APPLICATION/AGREEMENT
For Trench/Disturbance Permit within the City of New Bedford

Permit # 116-2023
Dig Safe: 20225104248
Date: 12/21/2022

Location of Work: Welcome St.
Wking from Rodney French Blvd. to McGurk St. (including intersections)
Relay Gas Main & Services

A		ISSUED FOR REVIEW	12/23/2022	HM/AB
NO.		DESCRIPTION	DATE	DW/CK/MP
REVISION STATUS				
EVERSOURCE ENERGY				
WEST RODNEY FRENCH BOULEVARD MAIN RELAY - PHASE 1				
NEW BEDFORD, MASSACHUSETTS				
LOCATION PLAN #2				
SCALE: 1"=20'				
SHEET 9 OF 30

LOCATION PLAN #2

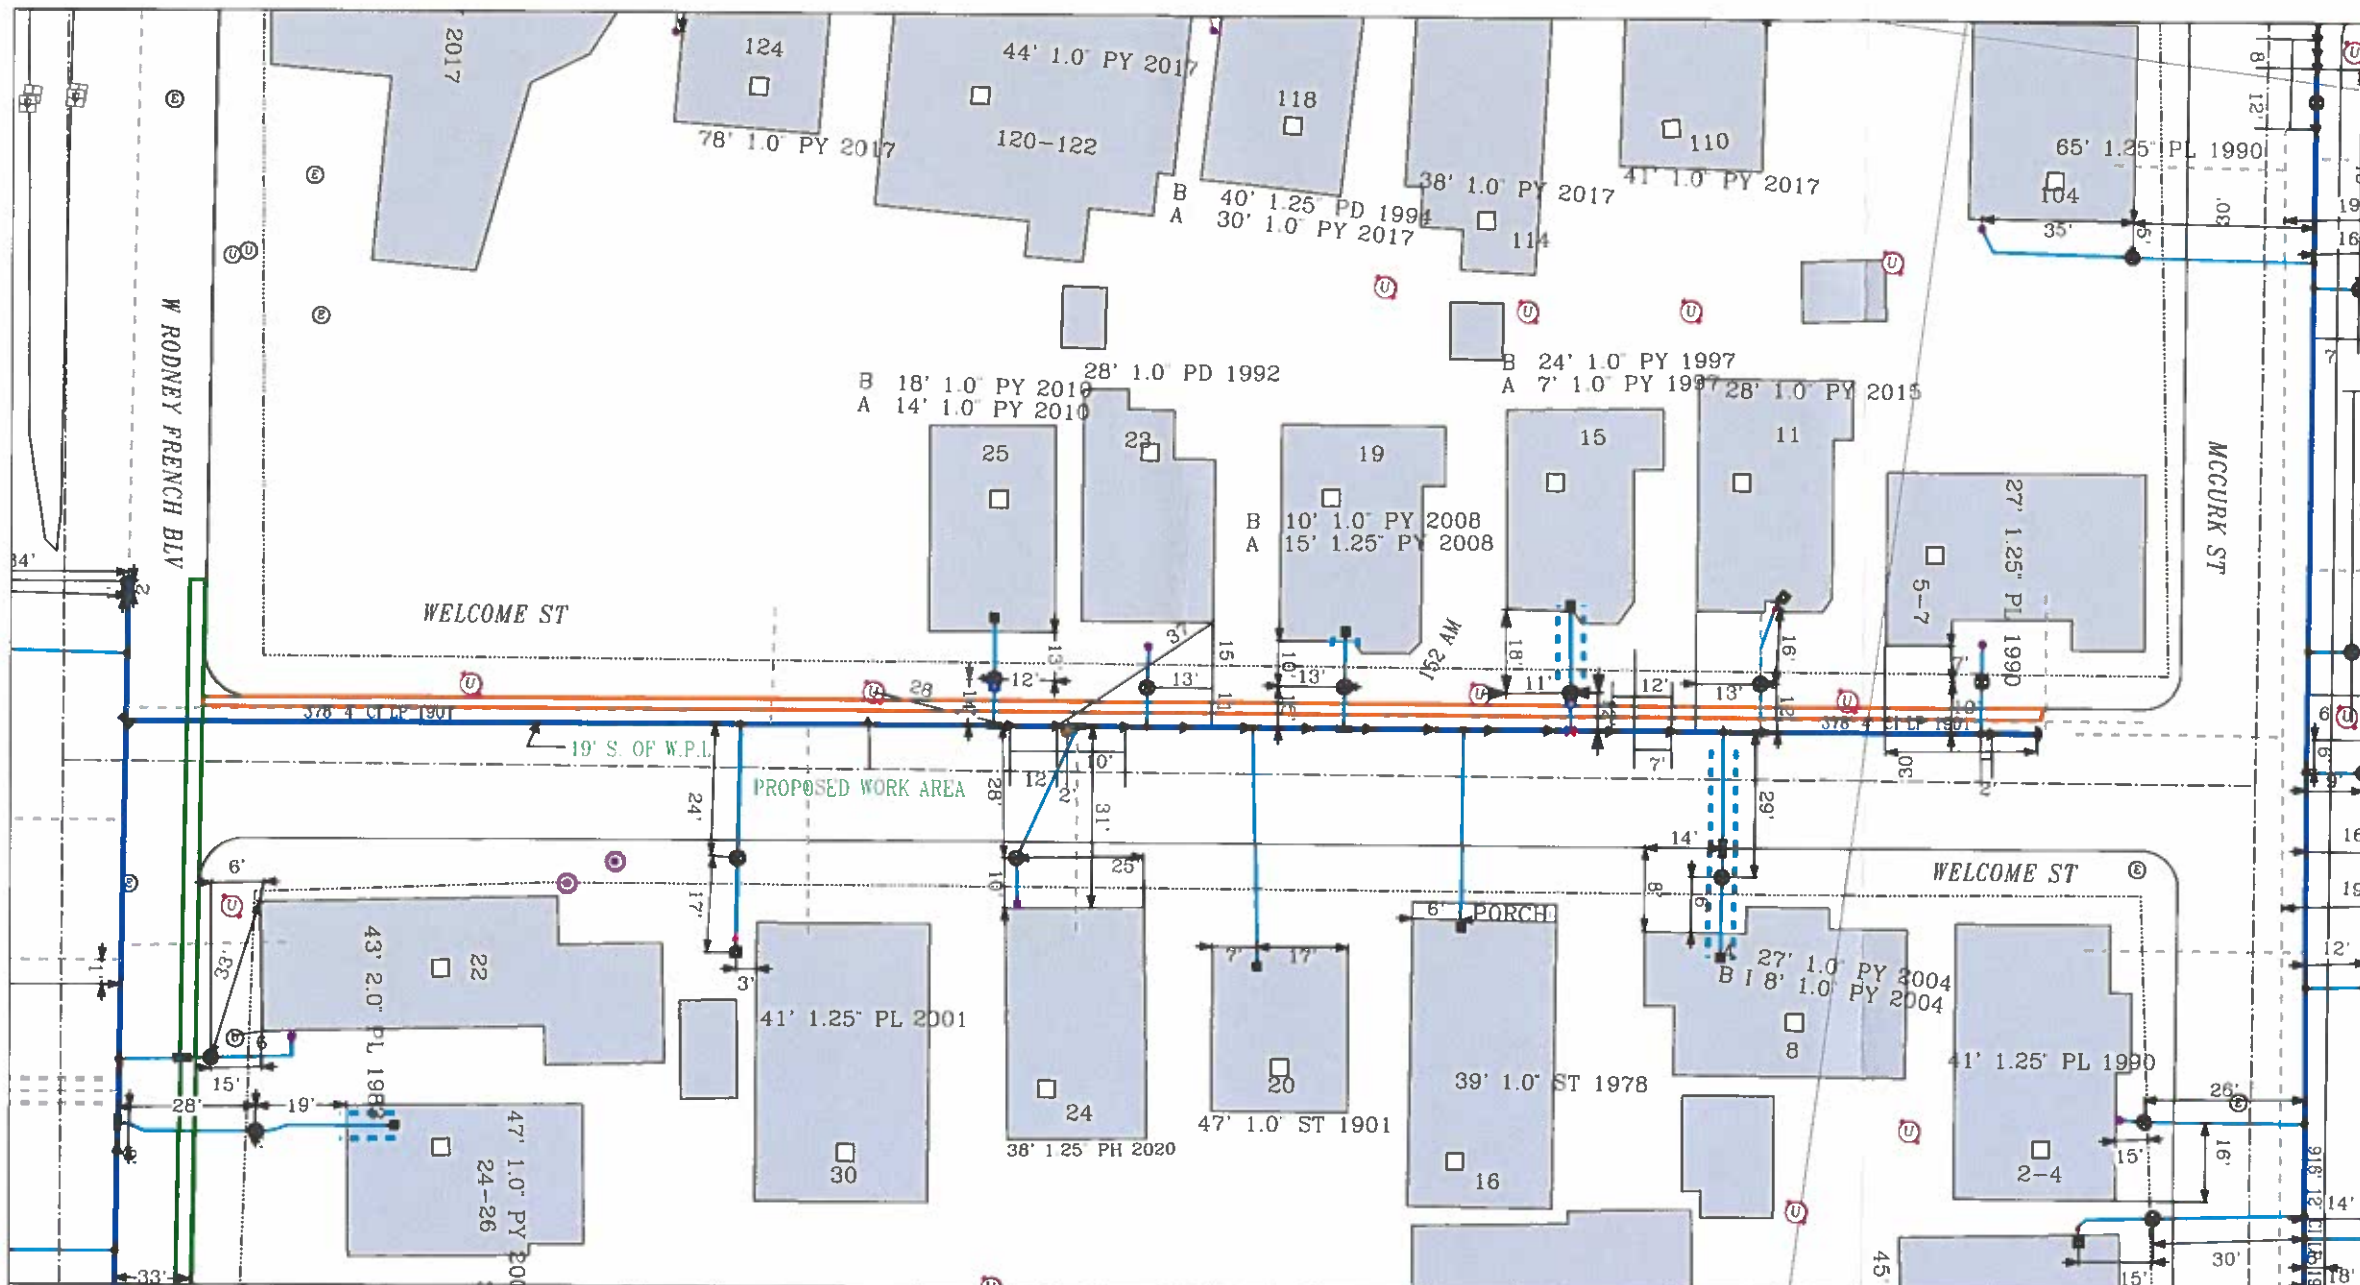
New Main to be located to the West of the ex. DMH.

proposed manhole
to be moved to the
East as discussed in
the field.

Will offset if
necessary to
maintain clearance
between ex. utilities.
